IREDELL COUNTY HEALTH DEPARTMENT

IMPROVEMENT PERMIT / AUTHORIZATION TO CONSTRUCT / OPERATION PERMIT / EXISTING SYSTEM INSPECTION

PERMIT# 115743 PIN# ~~4784-49-2445.000~~ 4789-49-3256 DATE 10-1-03

SUBDIVISION SPRING HILLS BLOCK / SECTION LOT 6 LOT AREA .645 AC SITE CLASS. PS DESIGN FLOW 360 L.T.A.R. .3

INITIAL SITE SKETCH

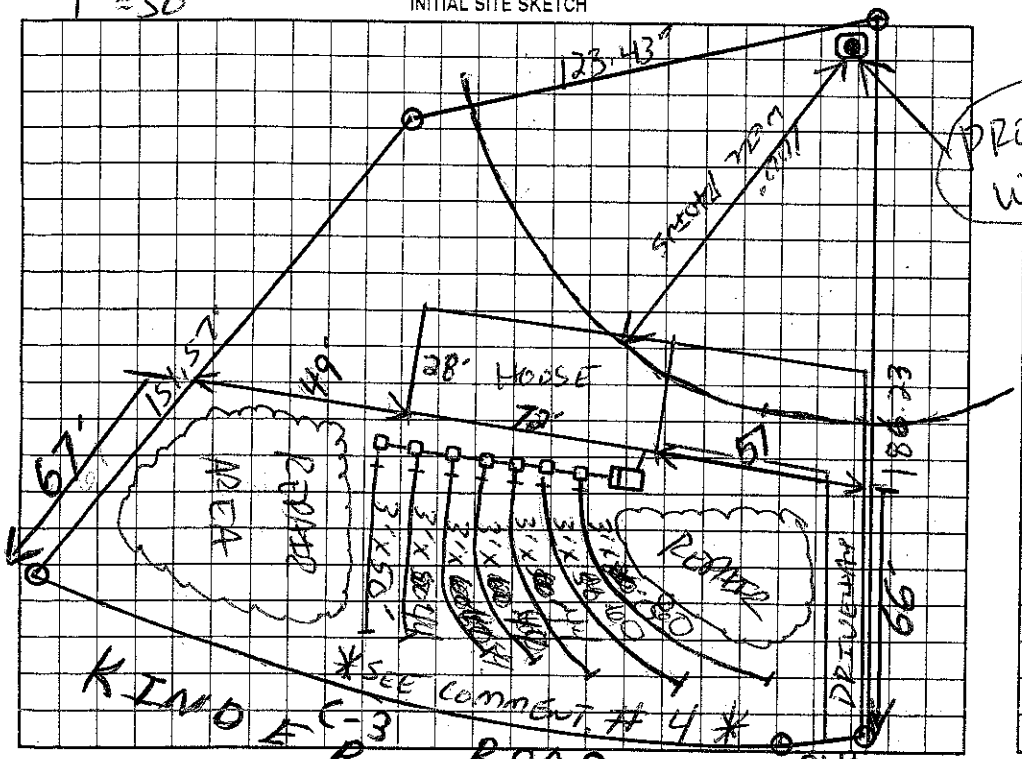
Comments:/Conditions: (1) INSTALL LINES ON CONTOURS (2) MAINTAIN SETBACKS (3) SYSTEM & HOUSE IS FLAGGED OUT (4) KEEP END OF LINES 15' OFF TOP OF EMBANKMENT CUT, "AS FLAGGED"

"NOT TO SCALE" APPROVED CHANGES

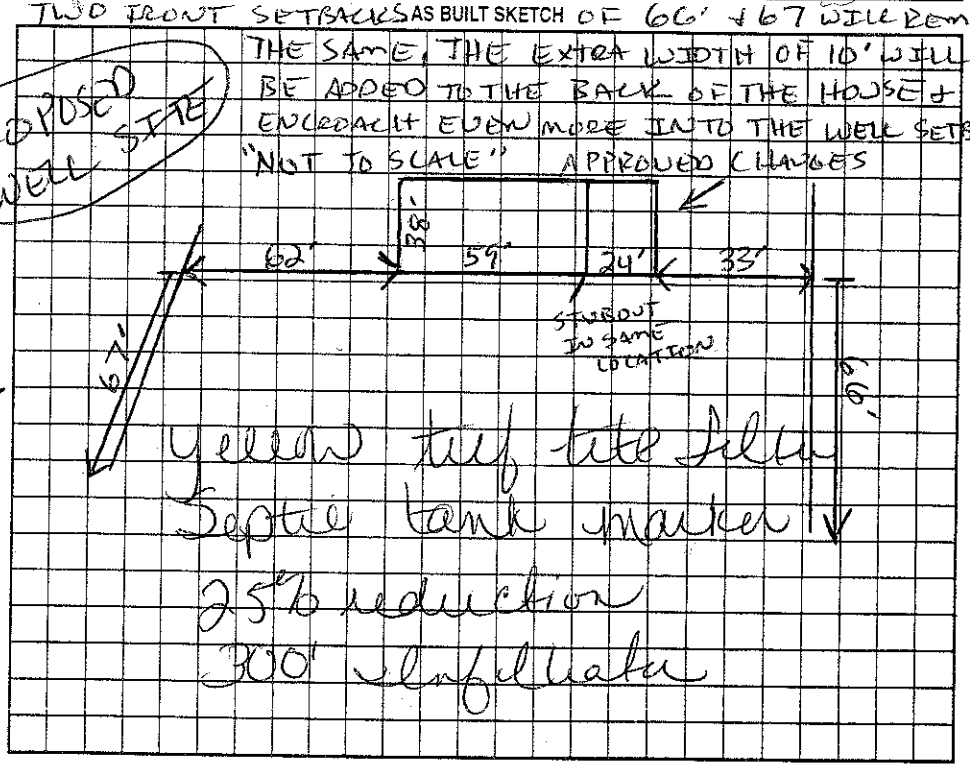
Comments:/Conditions: LC APPROVED 83'X38' HOUSE PLAN. 24'x24' GARAGE MUST BE 33' OFF SIDE P/L INSTEAD OF 57'. THIS WILL KEEP THE STUBOUT IN THE SAME LOCATION. THE 49' SETBACK WILL NOW BE 62' & THE TWO FRONT SETBACKS AS BUILT SKETCH OF 66' & 67' WILL REMAIN THE SAME, THE EXTRA WIDTH OF 10' WILL BE ADDED TO THE BACK OF THE HOUSE & ENCROACH EVEN MORE INTO THE WELL SETBACK.
